RECORD DRAWING

ONONDAGA COUNTY - DWEP
CLINTON CSO STORAGE FACILITY

ONONDAGA COUNTY • DEPARTMENT OF WATER ENVIRONMENT PROTECTION
 CLINTON CSO STORAGE FACILITY PROJECT

OVERFLOW CHANNEL PLANS
 STRUCTURAL

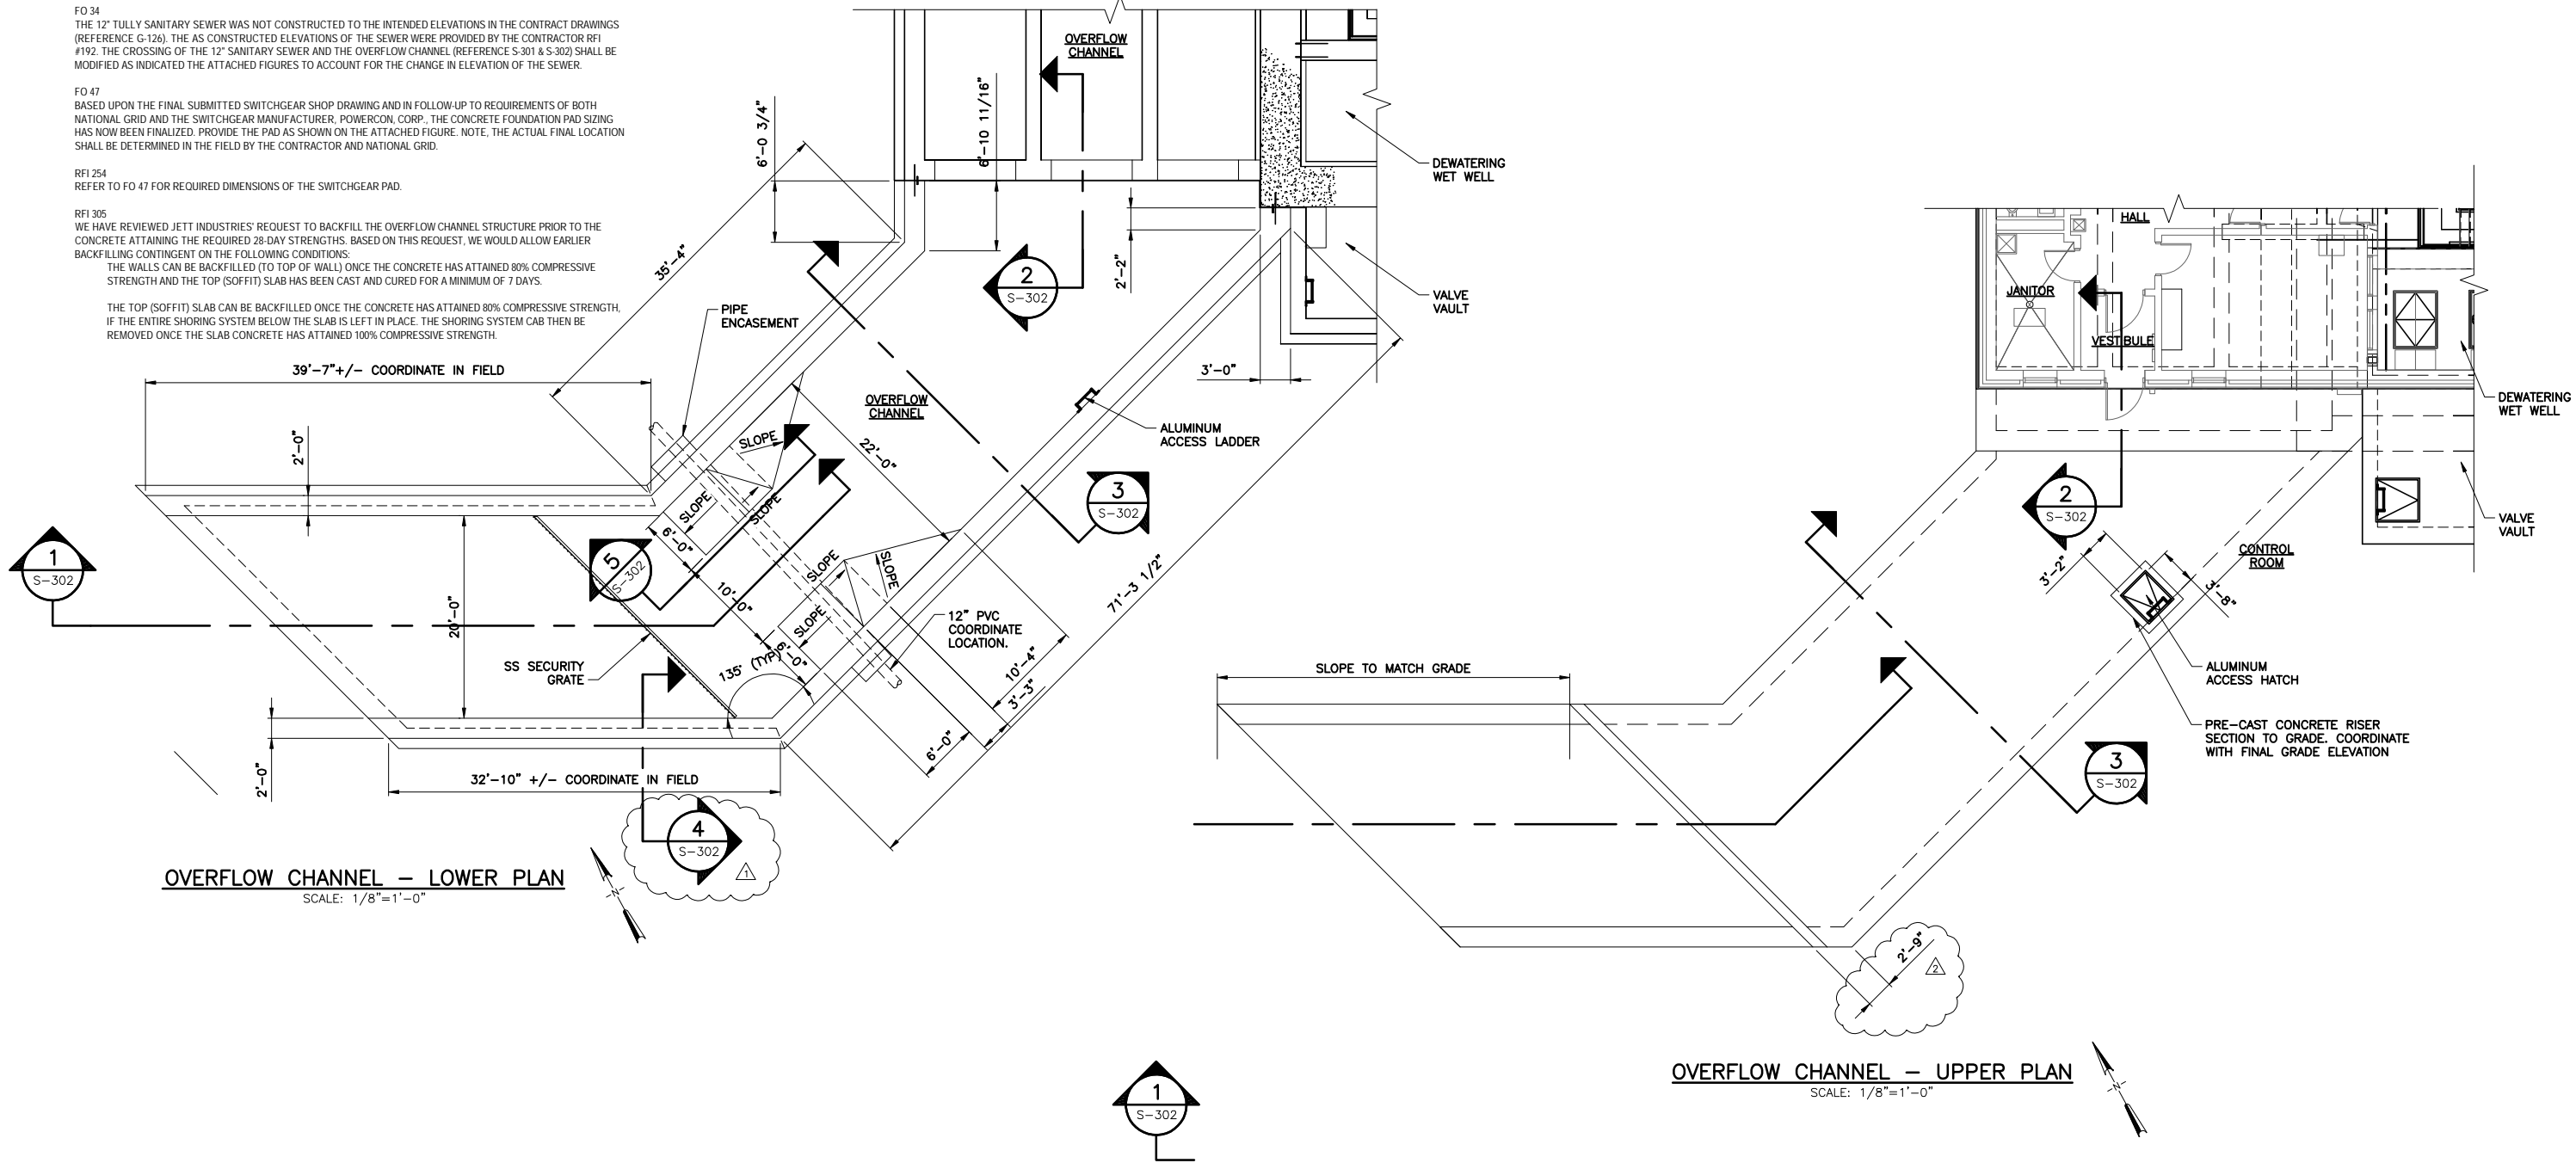
FO 34
 THE 12" TULLY SANITARY SEWER WAS NOT CONSTRUCTED TO THE INTENDED ELEVATIONS IN THE CONTRACT DRAWINGS (REFERENCE G-126). THE AS CONSTRUCTED ELEVATIONS OF THE SEWER WERE PROVIDED BY THE CONTRACTOR RFI #192. THE CROSSING OF THE 12" SANITARY SEWER AND THE OVERFLOW CHANNEL (REFERENCE S-301 & S-302) SHALL BE MODIFIED AS INDICATED THE ATTACHED FIGURES TO ACCOUNT FOR THE CHANGE IN ELEVATION OF THE SEWER.

FO 47
 BASED UPON THE FINAL SUBMITTED SWITCHGEAR SHOP DRAWING AND IN FOLLOW-UP TO REQUIREMENTS OF BOTH NATIONAL GRID AND THE SWITCHGEAR MANUFACTURER, POWERCON, CORP., THE CONCRETE FOUNDATION PAD SIZING HAS NOW BEEN FINALIZED. PROVIDE THE PAD AS SHOWN ON THE ATTACHED FIGURE. NOTE, THE ACTUAL FINAL LOCATION SHALL BE DETERMINED IN THE FIELD BY THE CONTRACTOR AND NATIONAL GRID.

RFI 254
 REFER TO FO 47 FOR REQUIRED DIMENSIONS OF THE SWITCHGEAR PAD.

RFI 305
 WE HAVE REVIEWED JETT INDUSTRIES' REQUEST TO BACKFILL THE OVERFLOW CHANNEL STRUCTURE PRIOR TO THE CONCRETE ATTAINING THE REQUIRED 28-DAY STRENGTHS. BASED ON THIS REQUEST, WE WOULD ALLOW EARLIER BACKFILLING CONTINGENT ON THE FOLLOWING CONDITIONS:
 THE WALLS CAN BE BACKFILLED (TO TOP OF WALL) ONCE THE CONCRETE HAS ATTAINED 80% COMPRESSIVE STRENGTH AND THE TOP (SOFFIT) SLAB HAS BEEN CAST AND CURED FOR A MINIMUM OF 7 DAYS.

THE TOP (SOFFIT) SLAB CAN BE BACKFILLED ONCE THE CONCRETE HAS ATTAINED 80% COMPRESSIVE STRENGTH. IF THE ENTIRE SHORING SYSTEM BELOW THE SLAB IS LEFT IN PLACE. THE SHORING SYSTEM CAN THEN BE REMOVED ONCE THE SLAB CONCRETE HAS ATTAINED 100% COMPRESSIVE STRENGTH.

SECTION 1-1-1
 SCALE: 3/16"=1'-0"

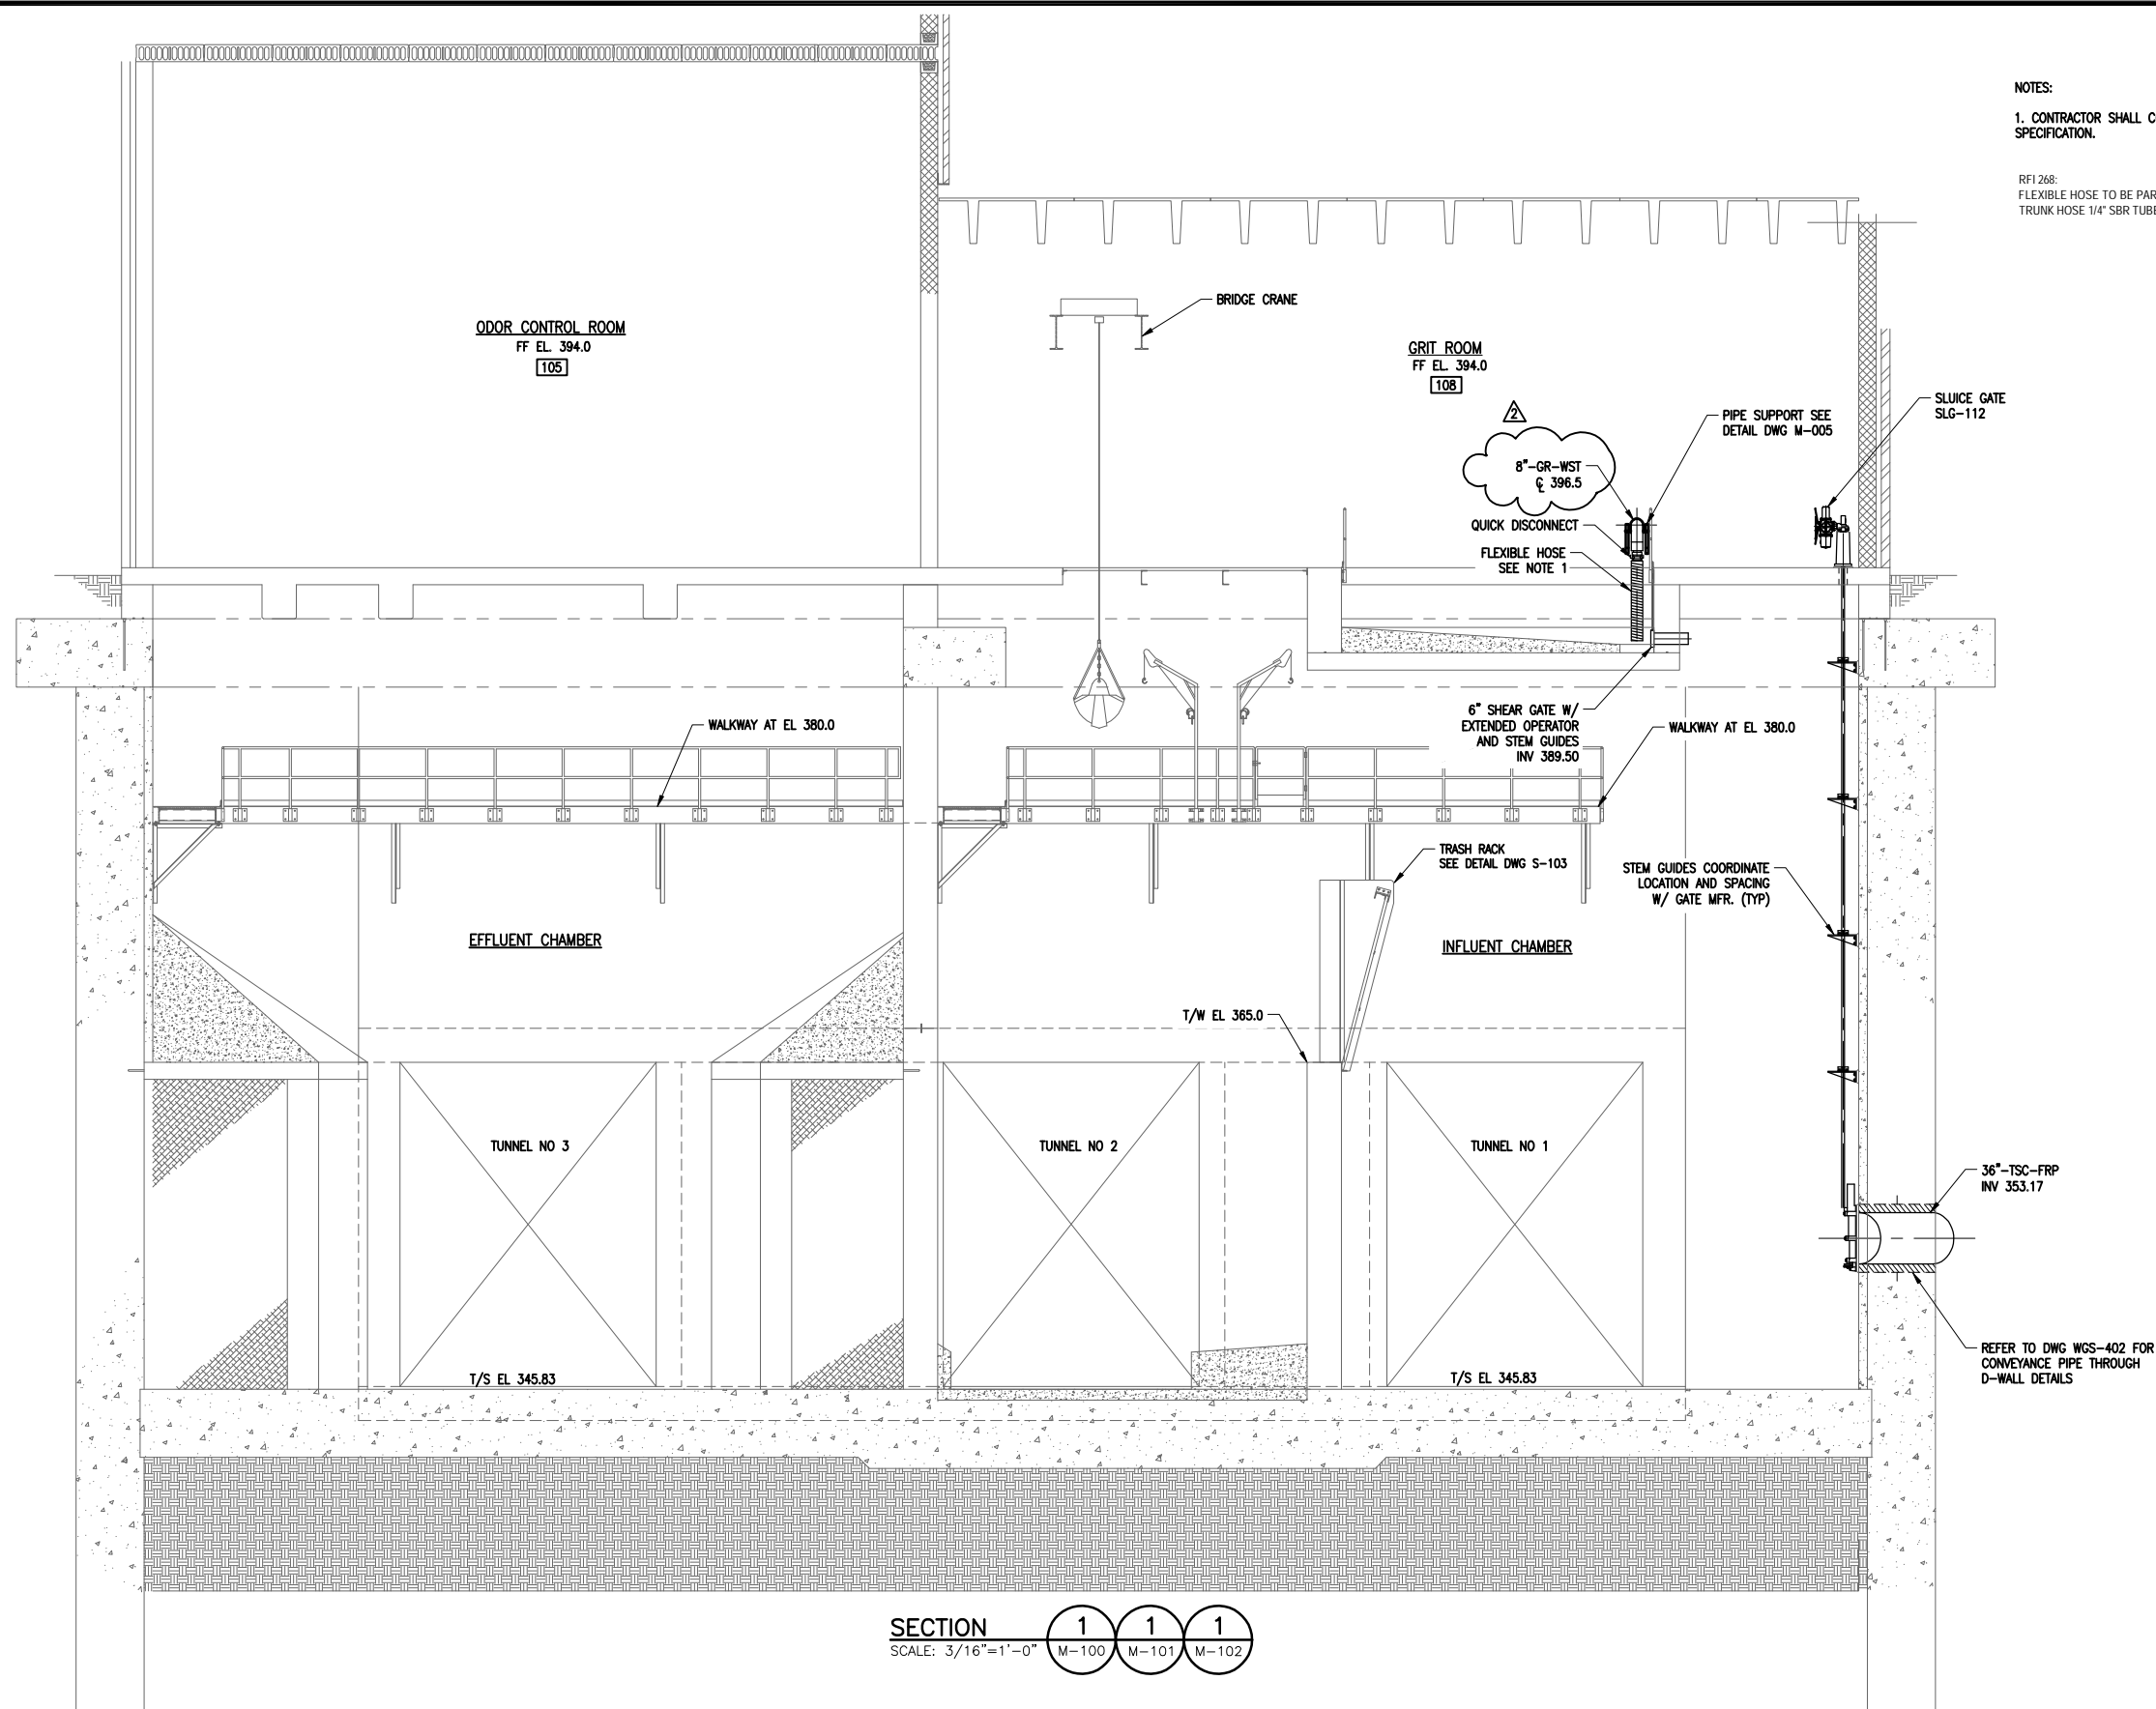
RFI 268:
 FLEXIBLE HOSE TO BE PARKER / TITAN EWC 789 CORRUGATED VACUUM TRUNK HOSE 1/4" SBR TUBE.

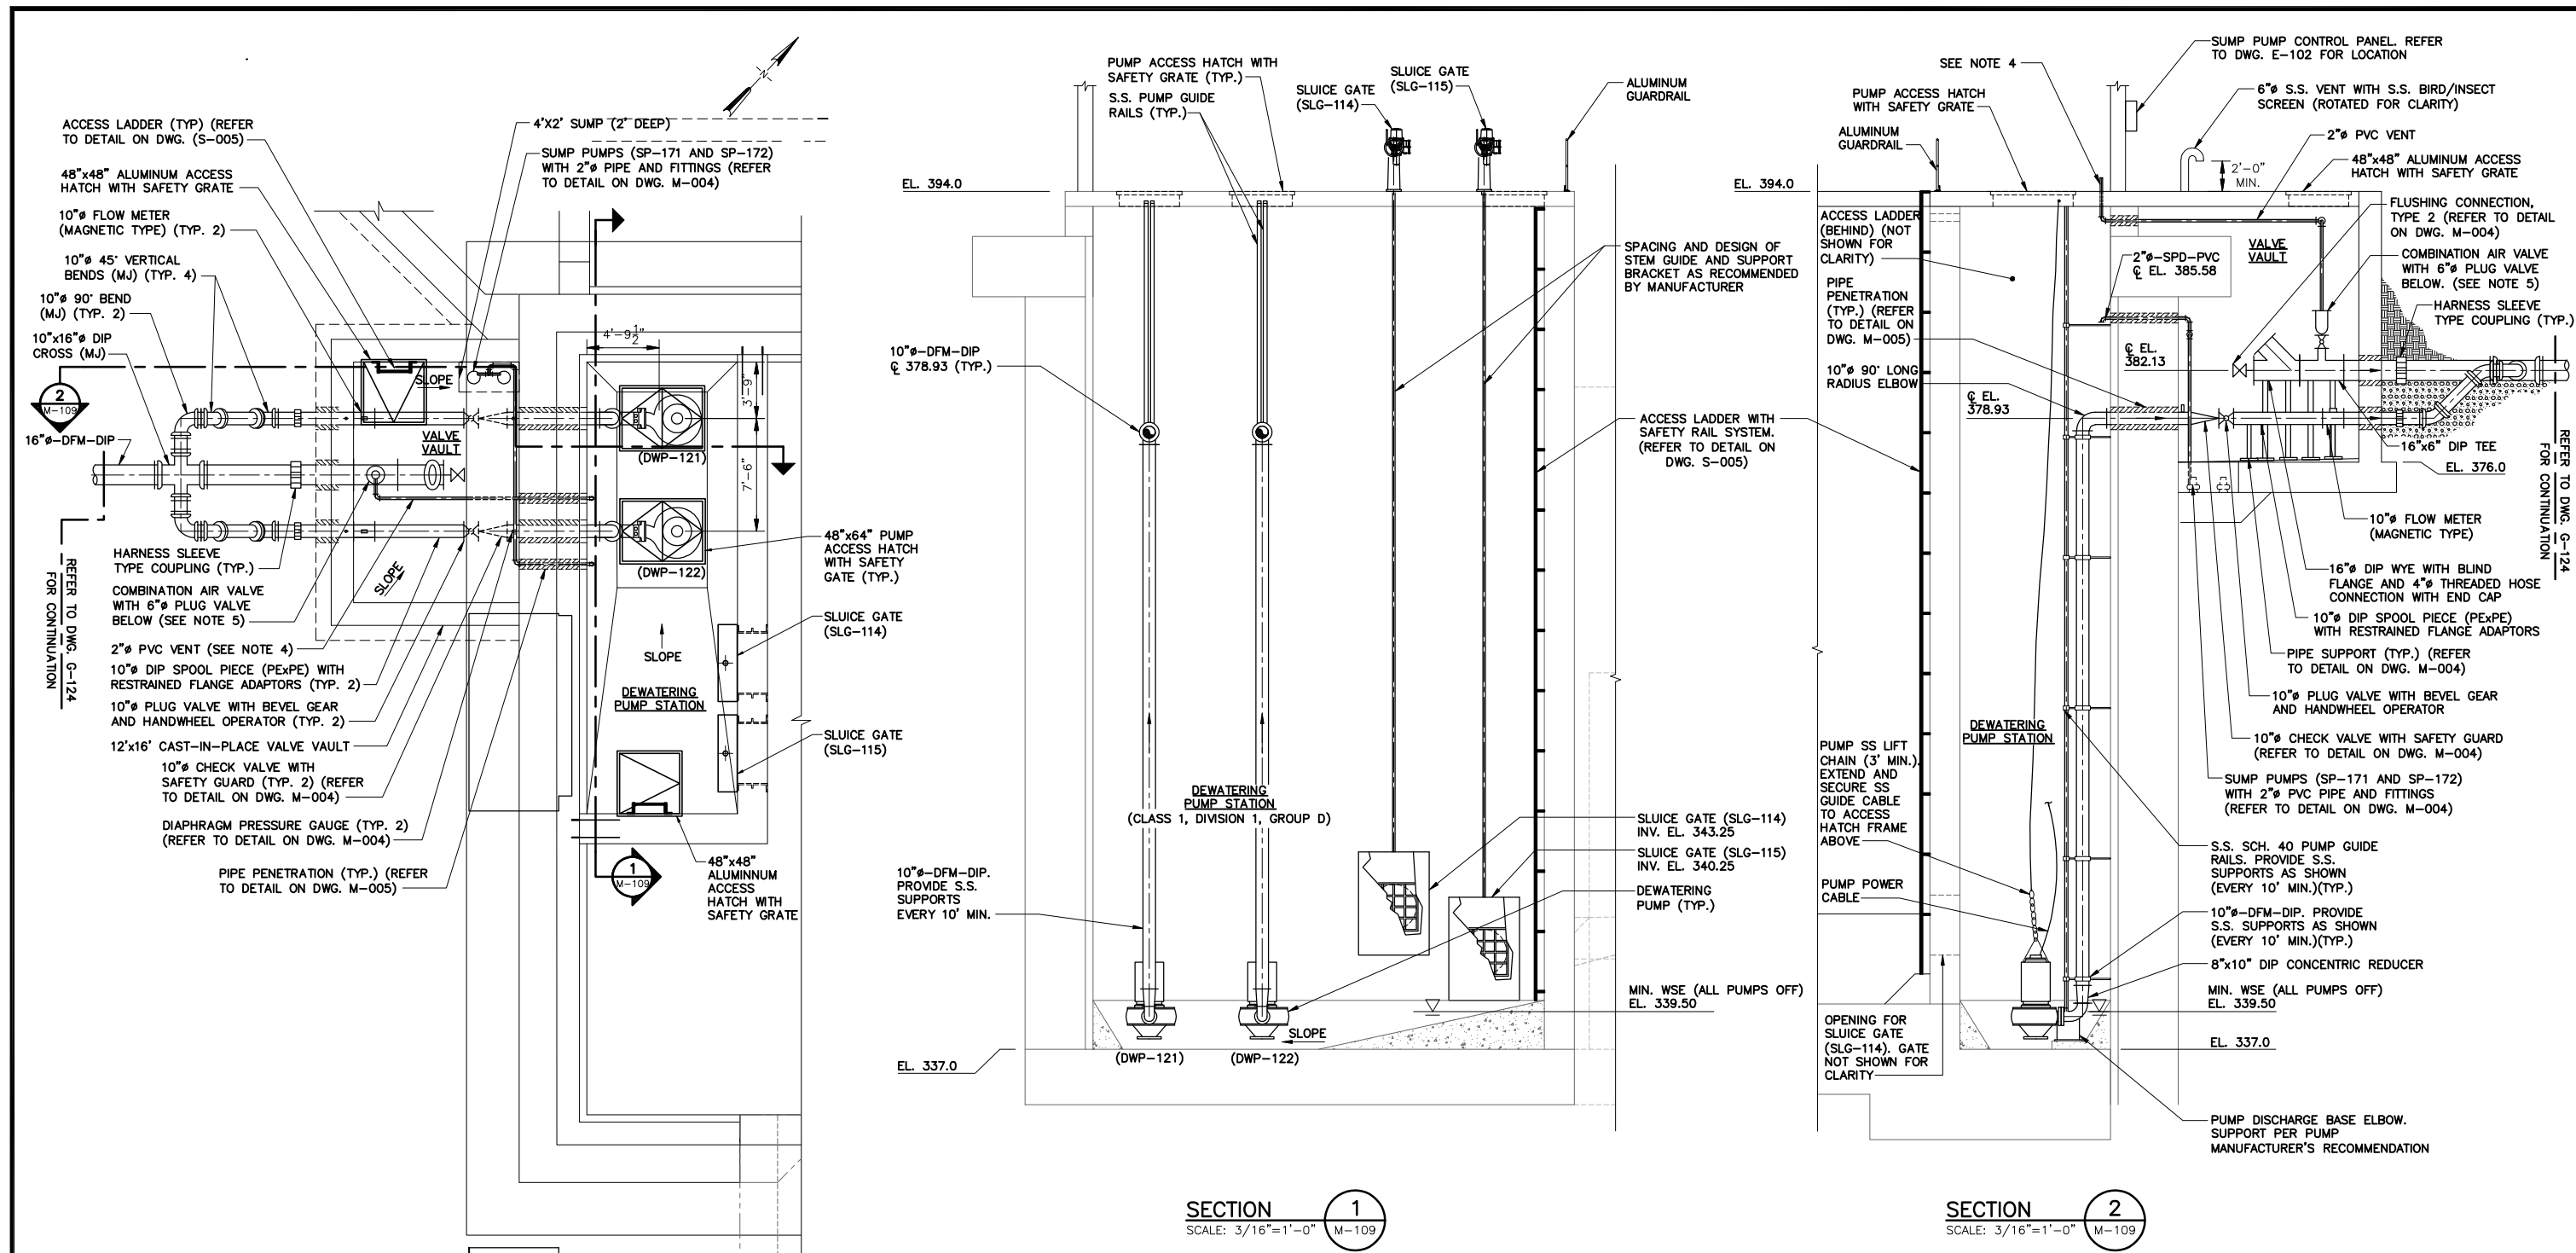
RF1245
THE HARNESS SLEEVE TYPE COUPLINGS DEPICTED AND CALLED OUT ON CONTRACT DRAWING M-109 SHALL ALLOW MOVEMENT/SETTLEMENT (NOT RESTRAINT) IN THE PIPING SYSTEM BETWEEN THE BUILDING (VALVE VAULT) AND THE PIPING SYSTEM/FORCE MAINS OUTSIDE OF THE BUILDING.
